# SPARTAN CHASSIS, INC.

RSB05-400-001C

## RECALL SERVICE BULLETIN

**SUBJECT:** Ametek NGI Air Pressure Dash Indicator Calibration

**FIG. 2-1**

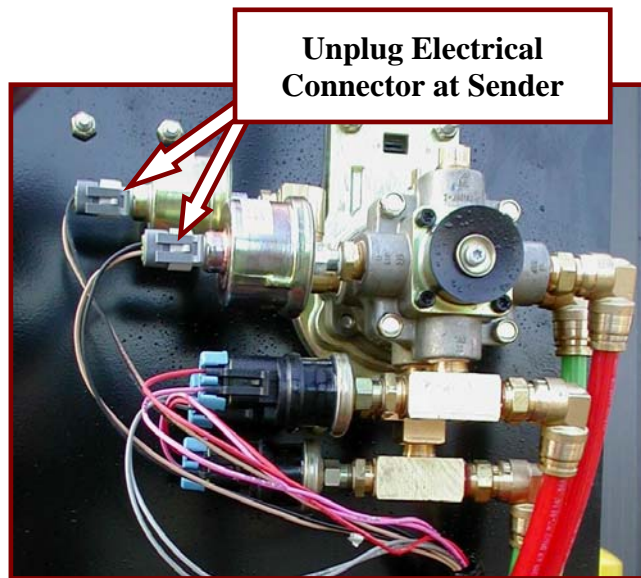
1. Observe all industry safety standards and secure vehicle to allow for disconnection of the air senders at the front of the treadle assembly.

**NOTE:** Disconnect **ONLY ONE** sender at a time to ensure proper reconnection.
